Increased accessibility reduces the cost

It has been known by inspections on the chipper heads that there has formed rust on the seats for the chipper knives.

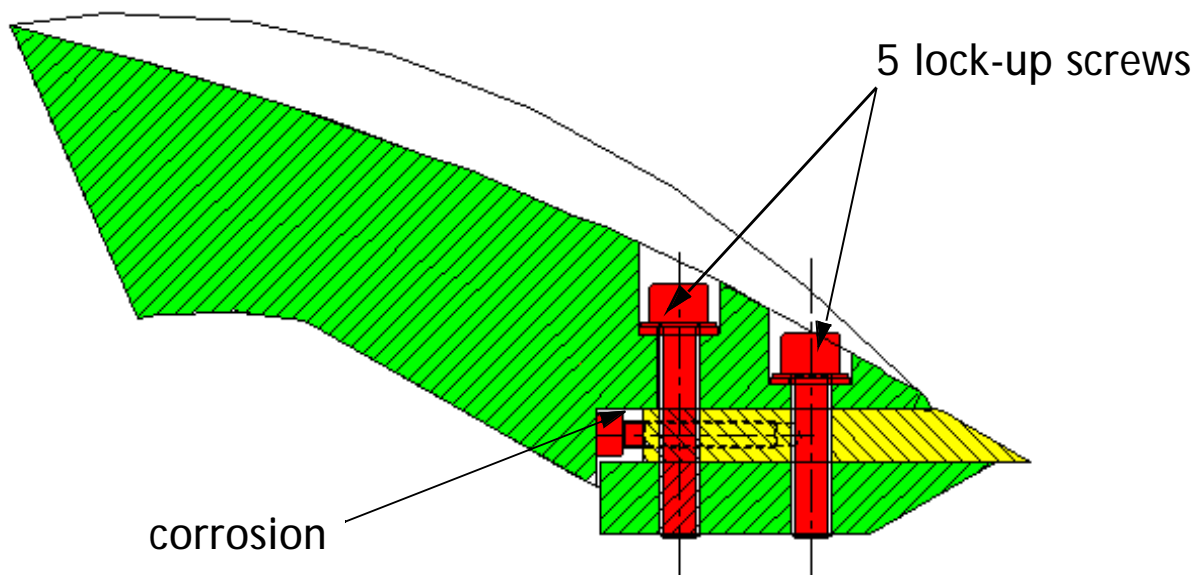
The corrosion makes a heightening so that a loose between knife and the contact surface can be the result when changing knives that are different much grinded or changing to new knives. This can lead to defects on the chipper heads which can result in broken screws and the knives get loose.

With this discovery, we have introduced 2 extra lock-up screws on the new chipper heads, to increase the security. The screws are situated behind the existing ones, to give a more stabil lock-up of the knives. To additionally secure a good lock-up of the knives it is very important not to grind more than 25 mm of the knives, since it increases the risk to get damage on the chipper heads and knives get loose.

To obstruct this it is important that the seats for the knives become cleaned at regular intervals, suitable as preventive service once a month. After cleaning and change of knives, the contact surface should be prepared with thin-boided slushing oil e.g. 5-56. The lockup screws and the washers should also be changed every 6.th month at 1-shift drive, to guarantee the strength.
